From: Stroud, Alfie [<mailto:Alfie.Stroud@camden.gov.uk>]
Sent: 08 July 2016 10:52
To: Peter Bovill <Peter.Bovill@montagu-evans.co.uk>; James Huish <James.Huish@Montagu-Evans.co.uk>; Marek Wojciechowski <marek@mw-a.co.uk>
Cc: Phillips, Kate <Kate.Phillips@camden.gov.uk>
Subject: 2016/1093/P - 20-21 King's Mews

Planning Response (8th July)
 Page 1/1

MWA Response:

Proposed Ground Floor Plan

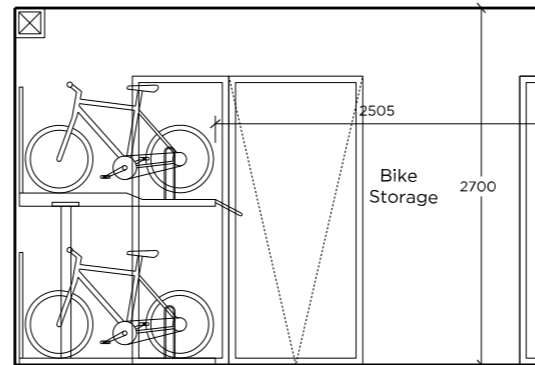
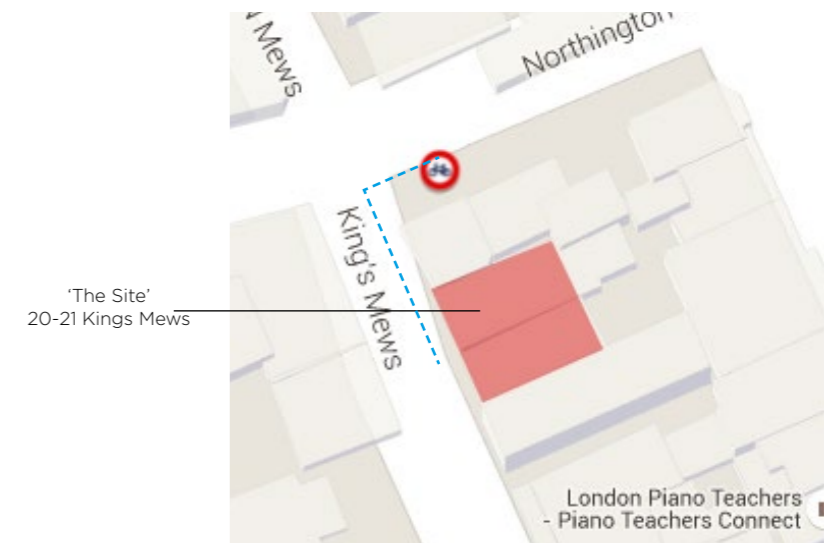
1) The proposed residential development consists of 7 units with 2 bedrooms or more. Therefore 14 cycle parking spaces are required to meet the minimum cycle parking requirement. The proposals would provide 14 cycle parking spaces. This meets the minimum requirement which is welcomed by Camden. However, there are concerns about the cycle parking details proposed.

It is proposed to provide Brompton cycles in each flat. This is not in accordance with CPG 7 guidance. Cycle parking facilities should be either Sheffield or Josta stands.

- 1) All doors have to be an absolute minimum of 900mm wide but preferably 1200mm for ease of access with a cycle. They should also either be automatic (probably over the top for a development this size), power assisted (preferable here) or suitable enough to prop open. This is particularly important with consecutive doors (as per this design). The proposed door into the cycle store looks a little small. I have tried to measure it off the pdf but it is not that accurate. Can a bigger door be installed here? Power assisted?
- 2) In addition to this can the applicant confirm that there is enough vertical clearance to install a 2-tier josta system? And horizontal clearance in front? CPG7 guidance asked for 2.7m high for a spacing of 400mm centres between stands or 2.5m high for a spacing of 650mm between stands. These details also need to be included on the revised drawing.

- 1) Noted. Door dimensions have been shown in drawing P_01 and doors to common areas are power assisted.
- 2) Bike storage with dimensions are indicated in P_01. Please refer to Page 16.0 Cycle Storage Strategy.

Cycle storage has been provided in the form of Camden bike stands, Cyclehoop wall anchors and contained within built-in joinery. The proposal provides a total of 13 secure cycle storages, which allows for 1 bike space per bedroom as per our pre-application advice and the London Plan, chapter 6; Table 6.3; Cycle Parking Standards.

As Proposed *
Isometric View Looking South West

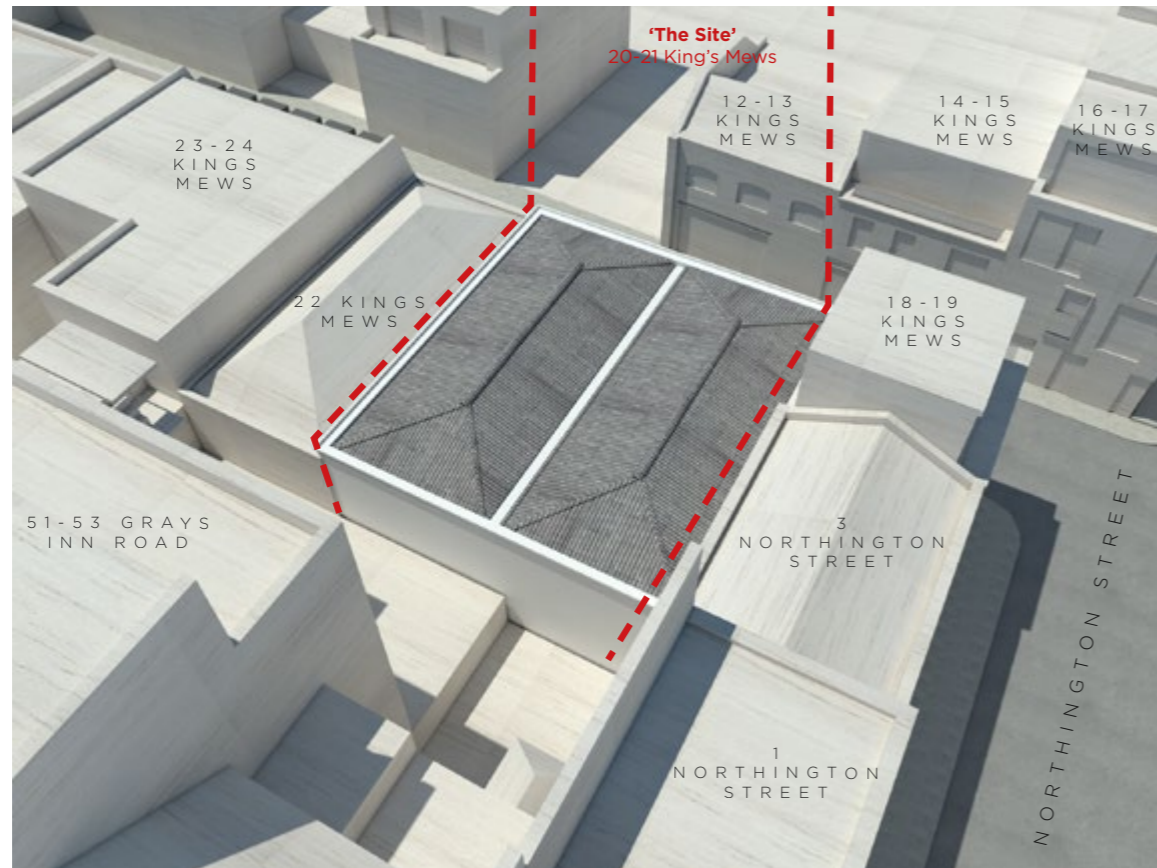
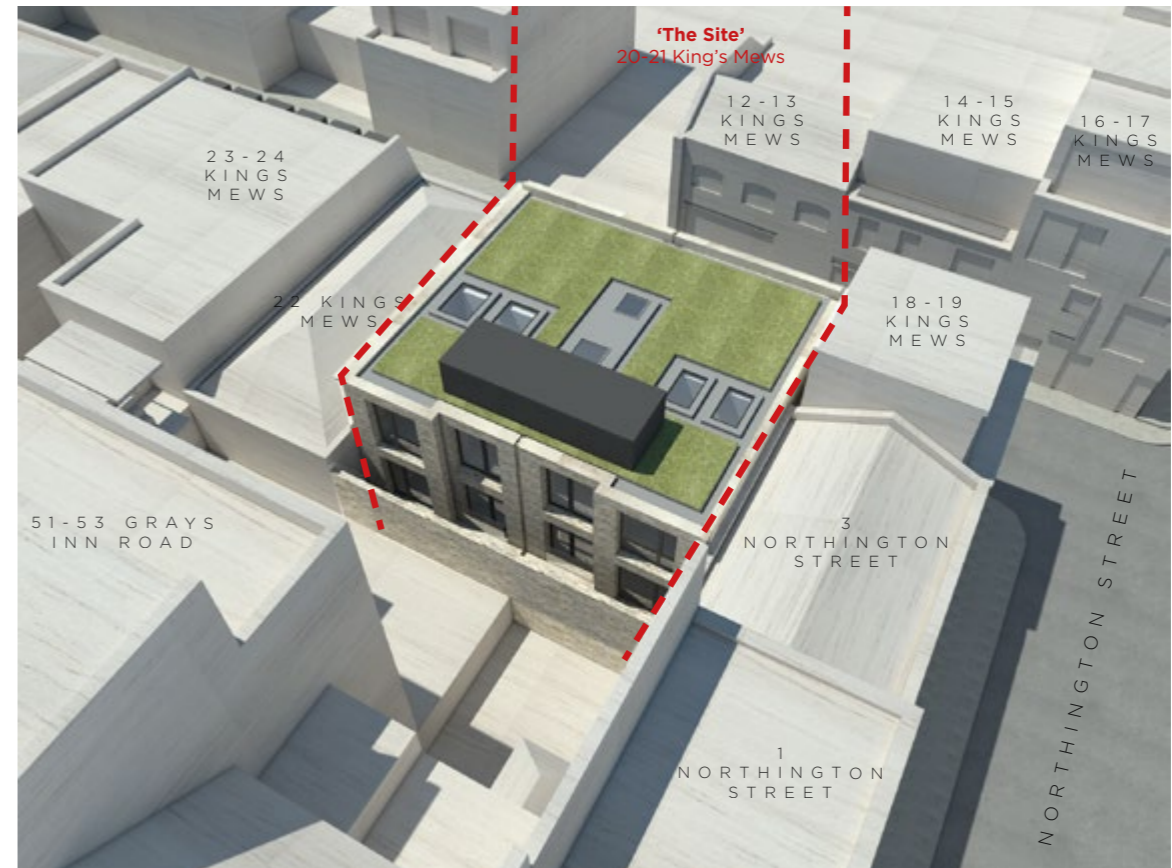
The design, particularly of the elevation to the mews, is undoubtedly an improvement on the pre-application scheme. The brickwork, including the soldier course detailing, promise to be an attractive and high-quality finish. However as I said in my email of 24 June, I'm not convinced that the proposed design goes as far as it might to conserve at least the contribution in character made by the existing building. The west elevations as proposed have much less of the simple solidity of the frontages that have characterised this part of the mews, and while in scale and the mixture of vertical and horizontal emphases they seem to fit the modern mews house typology, the traditional and vernacular qualities of the building to be demolished, which evidence the history of uses in the mews, will be lost. The proposal seems to respond explicitly to its context on the north side – the modern mews house on the corner – but very little to the rest of the mews.

The size and regularity of the window openings and so the balance of solid to void seem a big part²⁾ of the loss of character: is their large scale at second floor appropriate?, could the inset metalwork balustrades in the full-height windows at first floor be modified to give a bit more solidity here? The six windows along the length of the two buildings creates a very strong rhythm, which combined with the break-down of one plot into two (otherwise not contentious), makes for a very busy frontage; could this be softened if the two colours of brick did not contrast so much in tone, with each other, but also with the rest of the mews to the south?

2) West elevations proposed have been revised. The set back of the second floor emphasizes the subservient nature of the mews, in comparison to the ground and first floor. Stone reveals on the first floor have been removed, to create a simpler facade. The proposed rhythm of the openings takes reference from the existing mews typology along King's Mews. A study of the opening rhythm of the existing, consented and proposed schemes along King's Mews have been documented. Please refer to page 3.1 Varied Mews Typology and 3.2 Diagram of Opening Rhythm.

3) The window openings at the second floor have been reduced with a chamfer inset. A brickwall is proposed to be built in front of the metalwork balustrades at the first floor to create more solidity. The proposed brick type is more similar in tone. Please refer to P_13 Proposed Colour elevation Rev D.
